SITE PLAN REVIEW AND APPEARANCE BOARD STAFF REPORT

File No.: 2018-169-
SPF-SPR-CL5

Application Type: Class V Site Plan and Landscape Plan,–
36 SE 2nd Avenue Parking Lot

36 SE 2ND AV. DELRAY BEACH FL. -- PROPOSED SITE LAY-OUT
SCALE: 1" : 10'

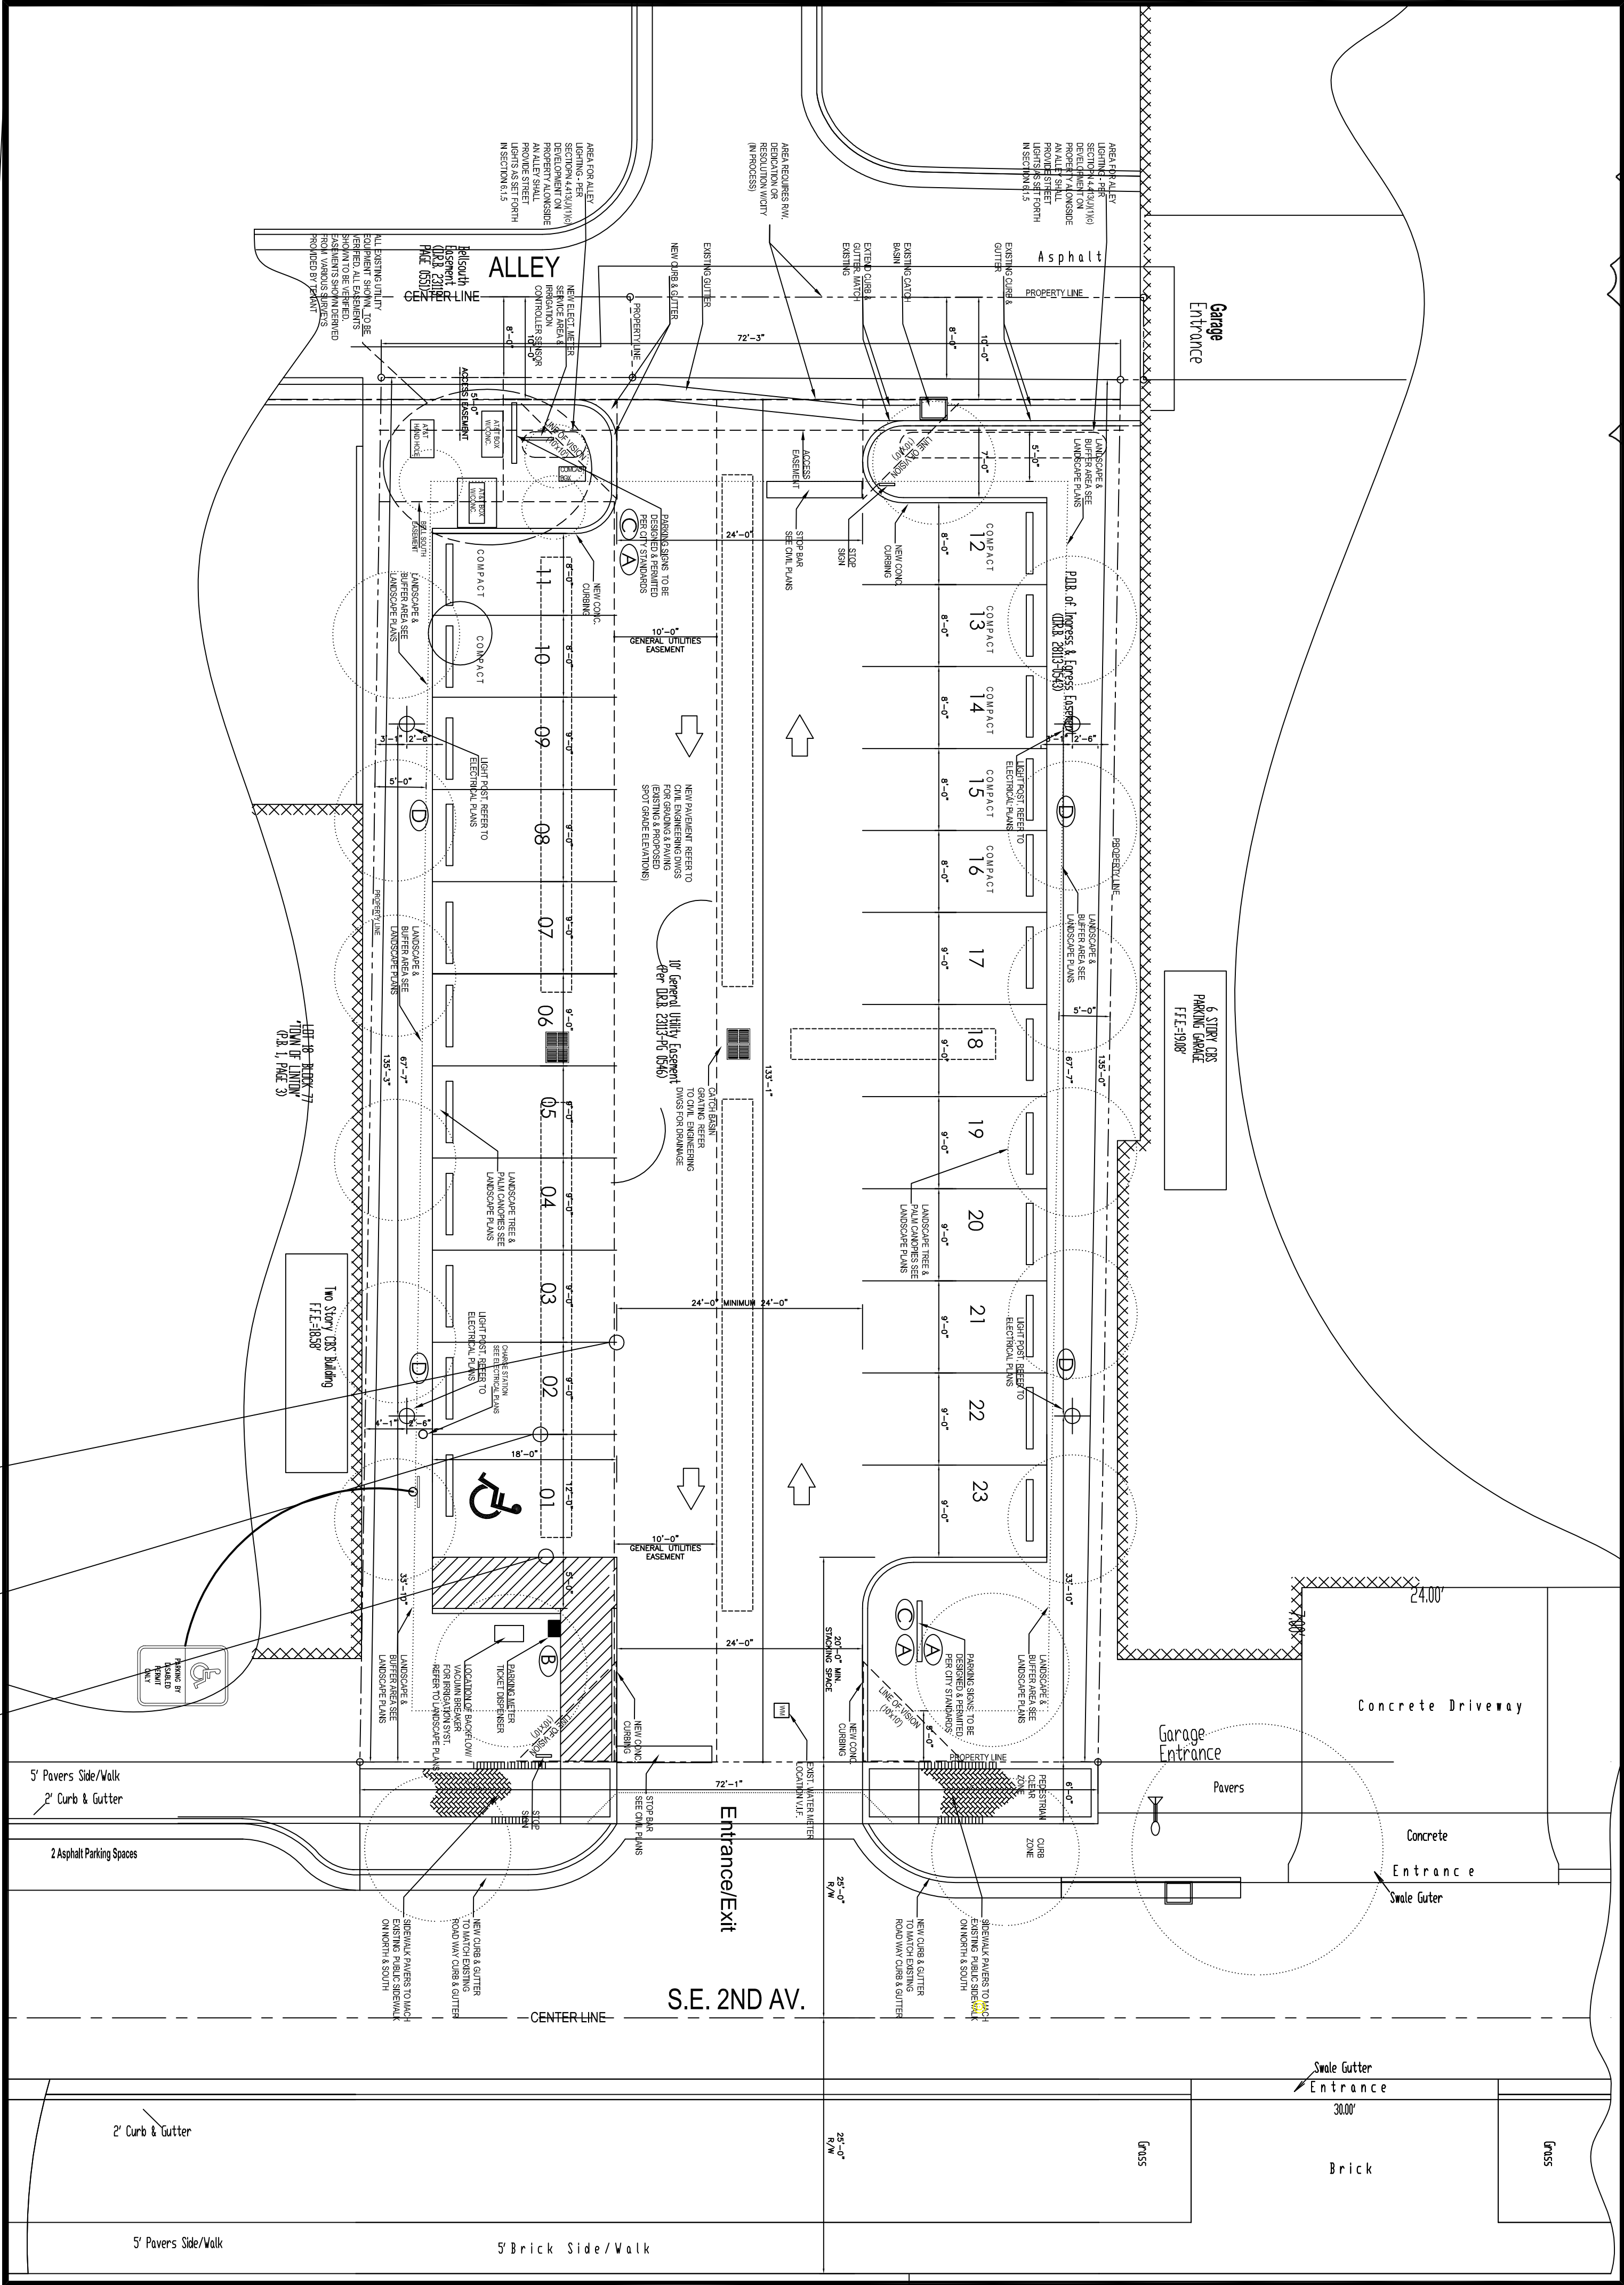
Pursuant to LDR Section 4.4.13(F)(7)(d), in the absence of a building façade, a streetwall is required along both Primary and Secondary Streets. Streetwalls shall be three-feet to three-feet, six inches in height, located in line with the building façade or the front setback. Streetwalls shall be composed of either an opaque wall of the same material and color as the building or of a continuous, maintained hedge. In addition, one shade tree per 30 lineal feet, uniformly spaced, shall be installed along the length the streetwall. The Applicant has chosen to utilize a continuous hedge of Podocarpus. **Prior to site plan certification, the specified height of the hedge shall be revised to a maximum of 42-inch in height and shall show an outline of the streetwall hedge on the site plan and note the maximum hedge height shall not exceed 42 inches in height.**

1. Prior to site plan certification, site must be platted or a plat exemption requested.
2. Prior to site plan certification, provide signage on the site plan for the alternative fuel parking space and charging station.

3. Prior to site plan certification, include the OR Book and Page number of the access easement on the site plan.
4. Prior to site plan certification, the specified height of the hedge shall be revised to a maximum of 42-inch in height and shall show an outline of the streetwall hedge on the site plan and note the maximum hedge height shall not exceed 42 inches in height.

8. Prior to building permit issuance, a bond for alley lighting shall be submitted.
9. Prior to building permit issuance, portions of the alley as shown on the site plan must be dedicated

36 SE 2ND AV. DELRAY BEACH FL - - PROPOSED PARKING LOT LANDSCAPE PLAN

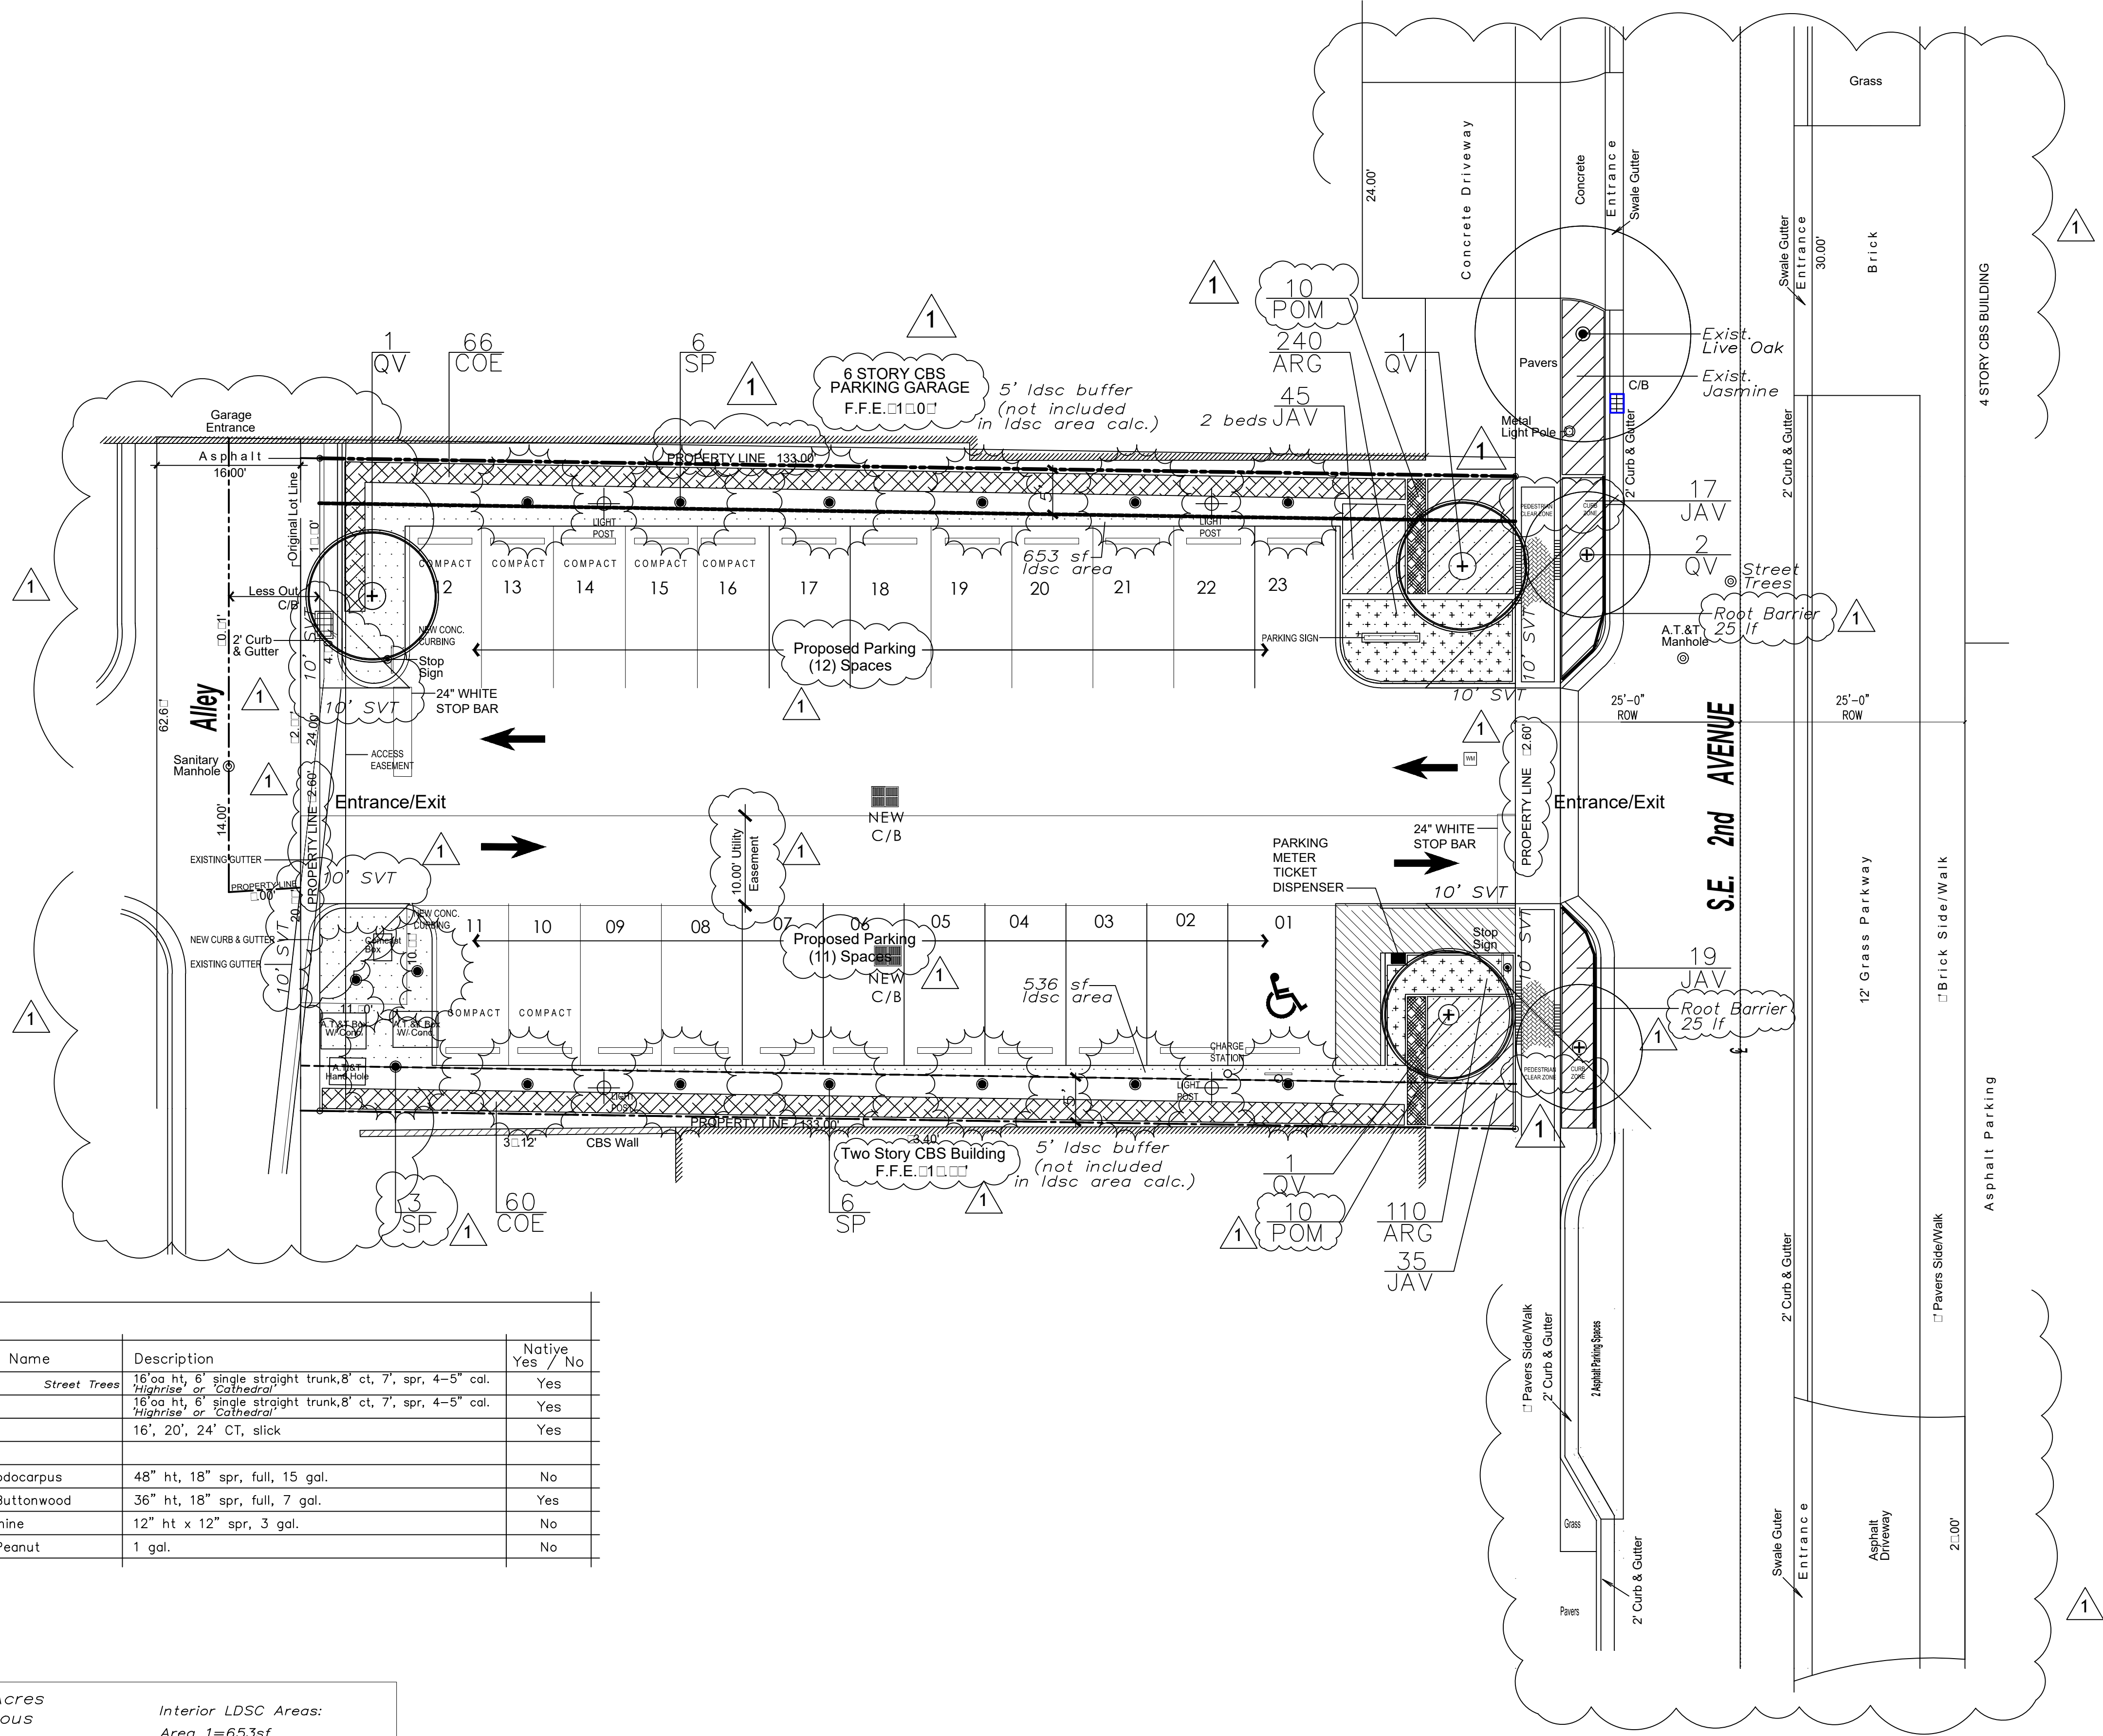
Pursuant to LDR section 4.6.16(C)(1)(a), prior to the issuance of a building permit for a structure or a paving permit, compliance with the requirements of Section 4.6.16 shall be assured through the review and approval of a landscape plan submitted pursuant to Section 2.4.3(C). A proposed landscape plan has been submitted and evaluated by the Senior Landscape Planner and found to be in compliance. Per Section 4.4.13(E)(2)(b), tree species have been planted in the public right-of-way uniformly spaced and planted within the curb zone. Several native species were utilized in the design. **Prior to building permit issuance, the property owner shall be required to enter into a maintenance agreement, in a form acceptable to the City Attorney, requiring the property owner to be responsible for and maintain any tree grates, irrigation, and landscaping installed by the property owner to meet the requirements of this section. The maintenance agreement shall be recorded prior to building permit issuance.**
